6280 Riverdale Street
San Diego, CA 92120
(877) 215-4321 | oneatlas.com

Atlas No. 10-57575PW
Report No. 4

**Subject: CGS Application No. 03-CGS5153
RESPONSE TO REVIEW COMMENTS
Geotechnical Investigation Report, Physical Education Complex
Replacement Compton Community College District, CA
1111 East Artesia Boulevard
Compton, California 90221**

ATTACHEMENT A'
KNA'S VRCS SHOP DRAWINGS SHEET KNA-3

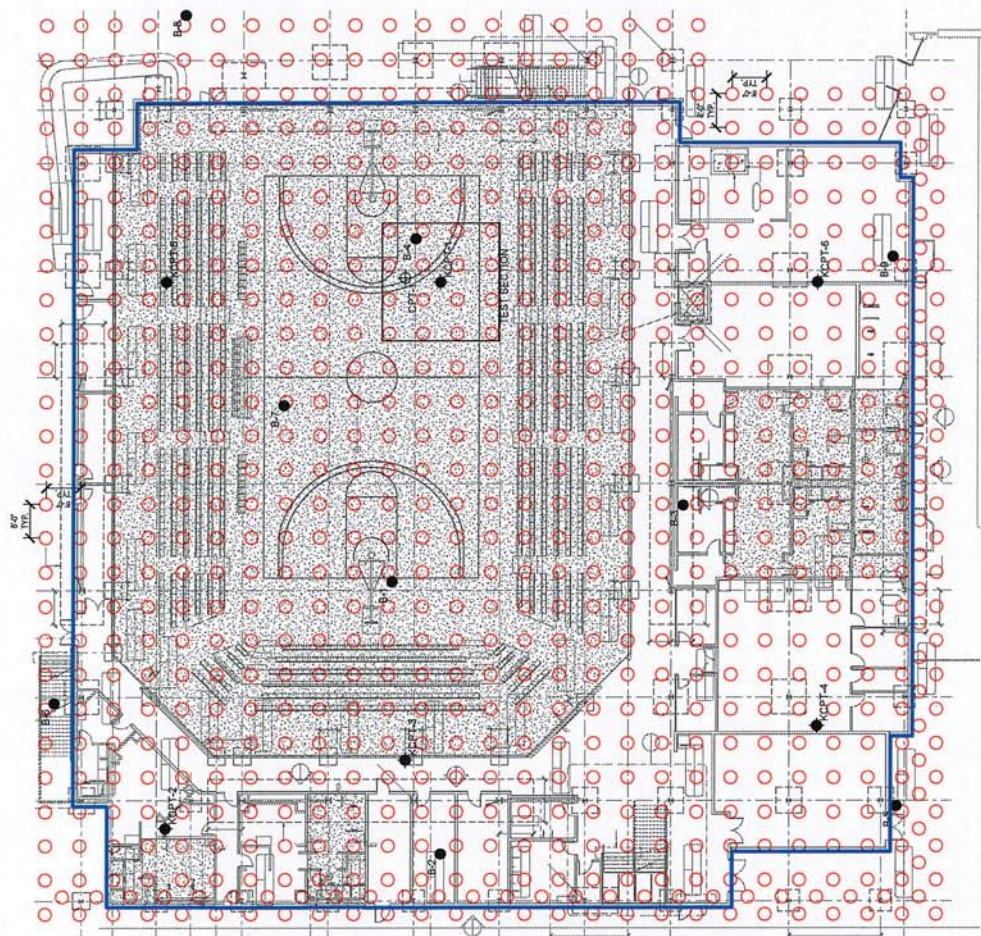
In accordance with the CGS Comment No. 22 (Reference 3), Atlas Technical Consultants (Atlas) has reviewed the Vibro Stone Column Design provided in Attachment A' and the Deep Soil Mixing Design provided in Attachment B', the design and plans, prepared by Keller North America (KNA). Our review was based on the geotechnical and geohazard aspects of the reviewed documents (Attachments A' and B') and was to verify that they are in general conformance with the recommendations provided in References 1 and 2.

Based on our review and to the best of our knowledge and understanding, it is our opinion that the proposed soil mitigation design and plans, provided in Attachments A' and B', including the depth of the mitigated soil, diameter, length, spacing and area replacement ratio (ARR) of the proposed Vibro Stone Columns and Deep Soil Mixing Columns have been prepared in general conformance with the recommendations provided References 1 and 2. ATLAS recommends performing necessary tests (field and lab) on the mitigated soil (DSM and VRSC) to evaluate the

behavior of the mitigated soil. Based on these tests results and analyses, the preliminary recommendations for the soil mitigations in references 1 and 2 and the design presented in the Attachments A' and B' may need to be modified (e.g., adding some additional rows of DSM and/or VRSC).

Sheet No. **KNA-2**
Scale: N/A

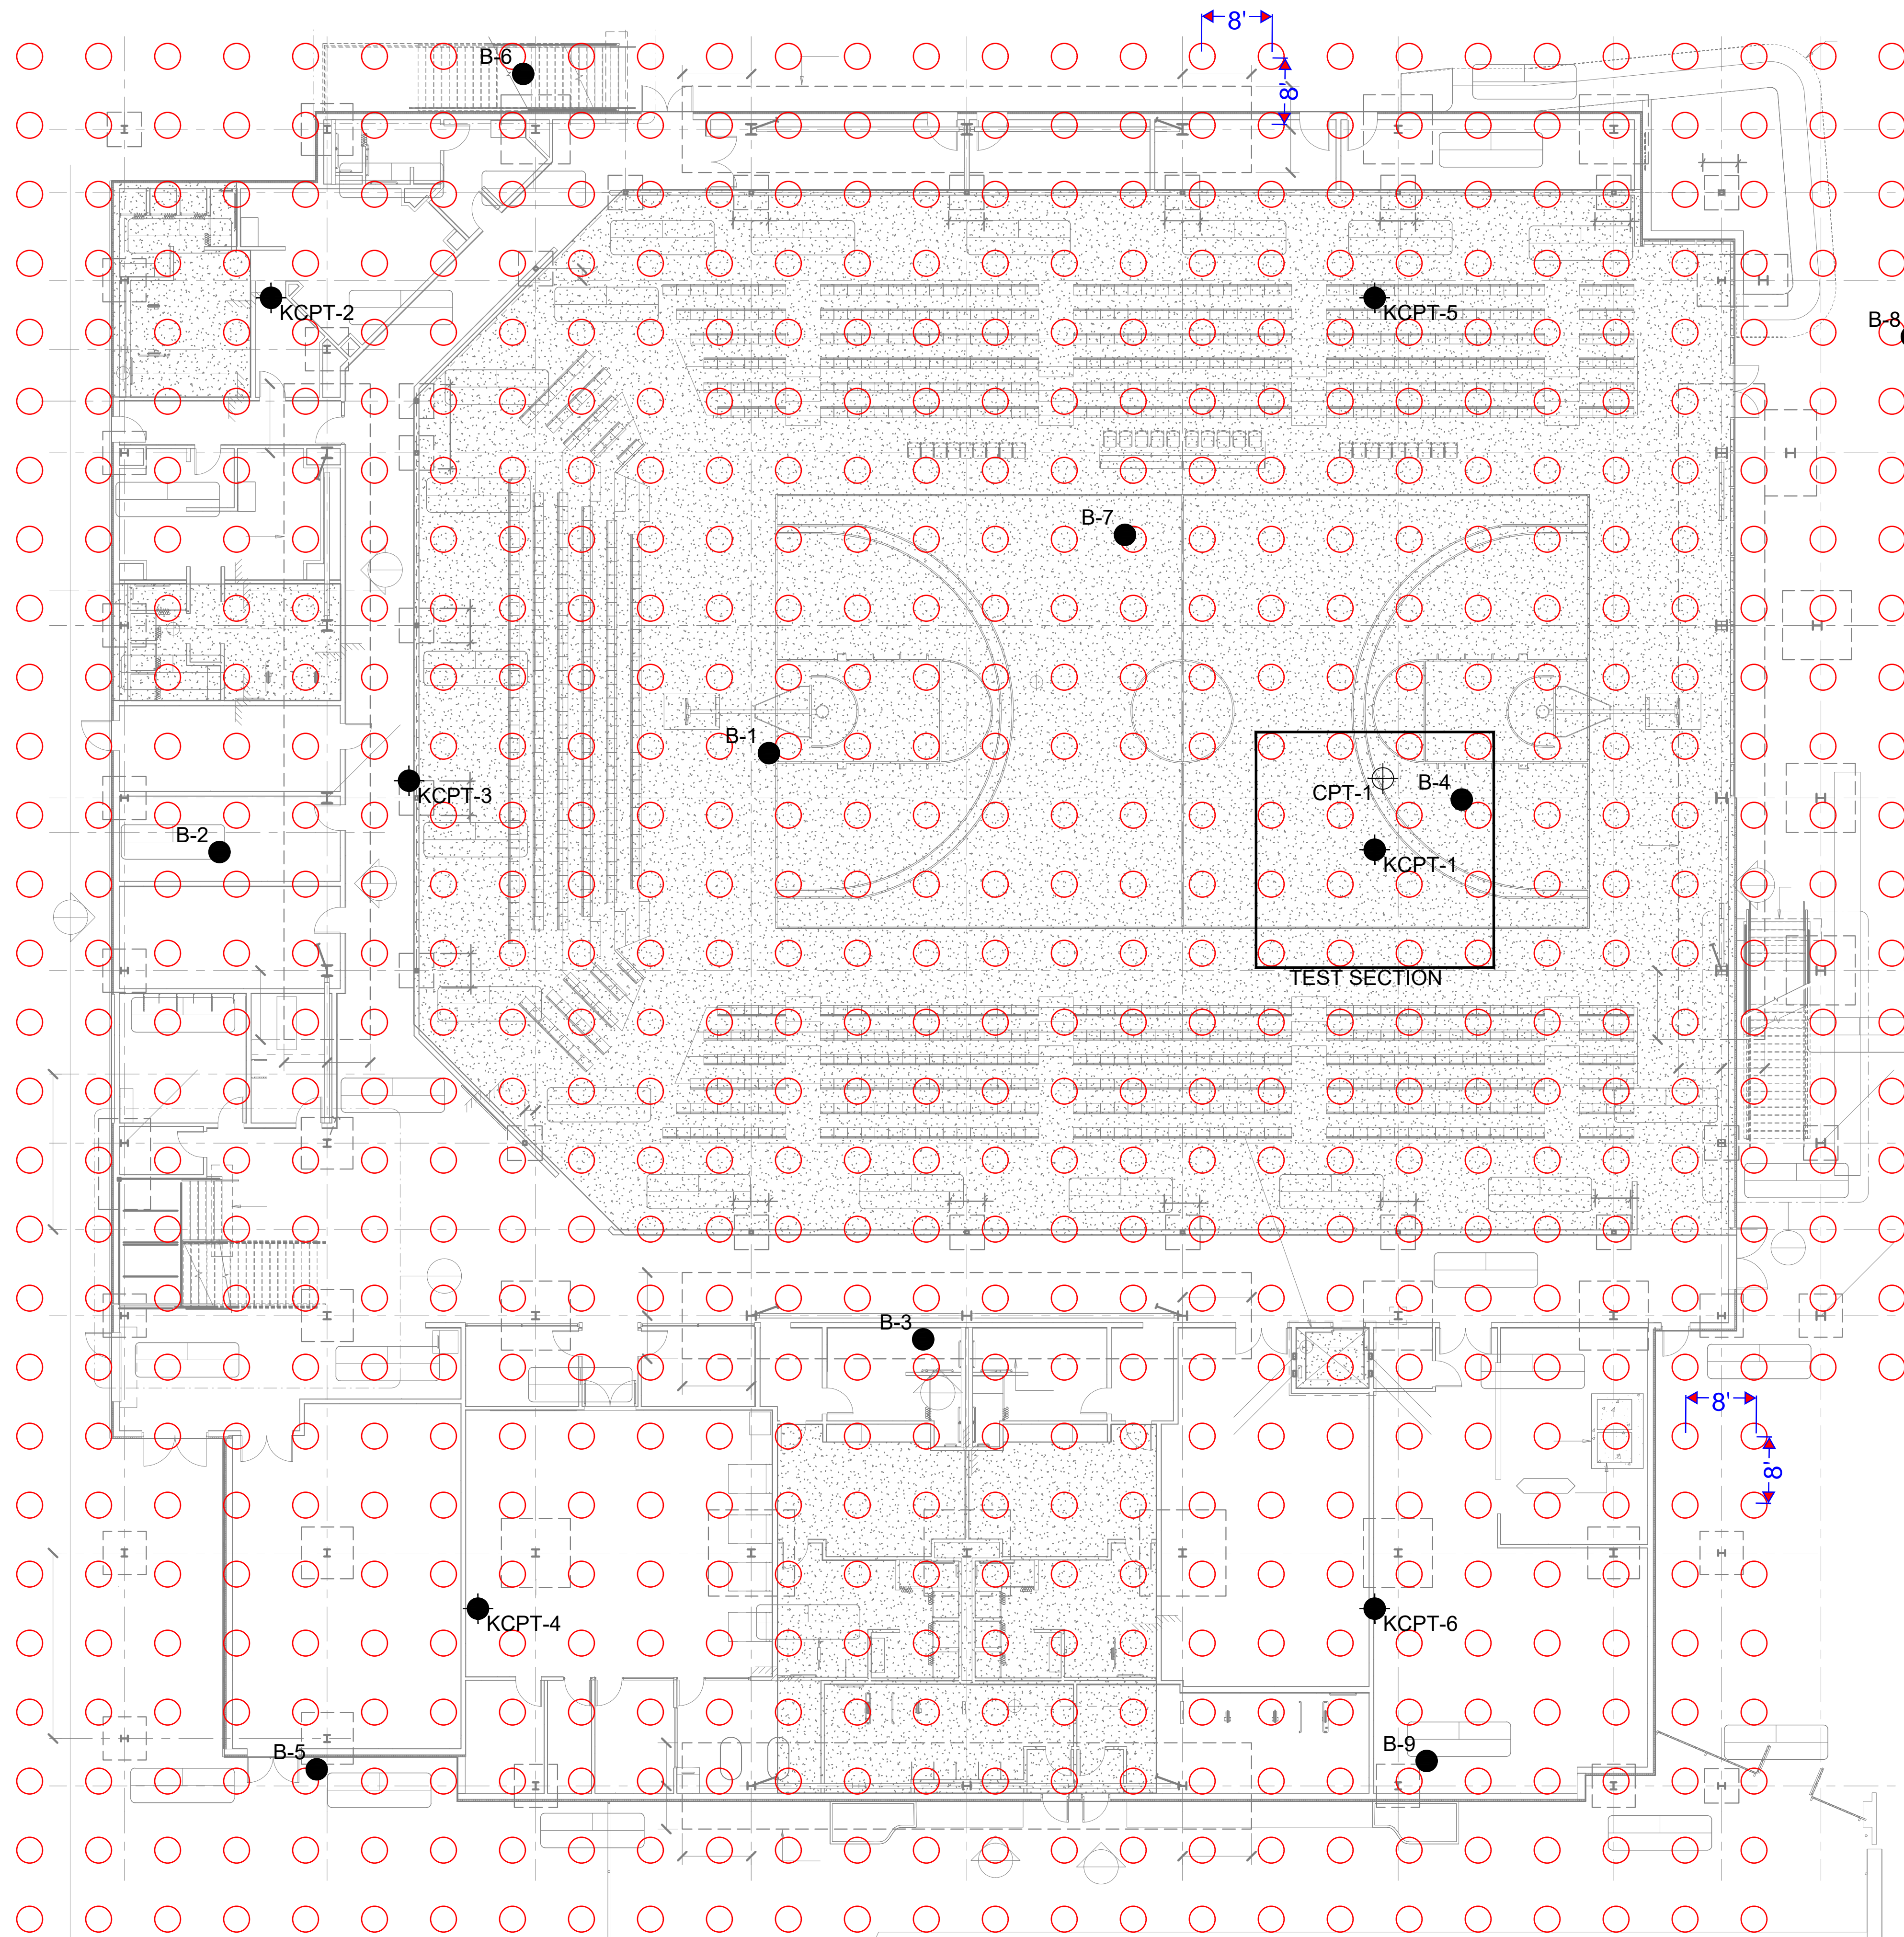
- CGS notes KNA provides discussion of QA/QC requirements and acceptance criteria for the DSM ground improvement in their design submittal and on Sheet KNA-2 of the shop drawings that generally appear to be reasonable and appropriate. However, a complete set of specifications for the installation, testing, and performance of the DSM system should be drafted and provided for CGS review. The specifications should include fully detailed and well-defined acceptance criteria for evaluation of the successful completion of the ground improvement and satisfaction of design and performance objectives.

- The consultants recommend that coring for verification should be performed on at least 2% of the DSM columns, which appears to be reasonable. However, CGS observes that a lower percentage of cores is shown in the Notes and Details on Sheet KNA-2 of the KNA shop drawings. KNA is requested to update these Notes to conform with the geotechnical recommendations. In addition, KNA is requested to revise their sampling statement and indicate that the coring locations should be selected by the GEOR for the project.

Keller has updated our shop drawings to reflect this comment.

Keller has updated both our submittal and shop drawings to reflect this comment.
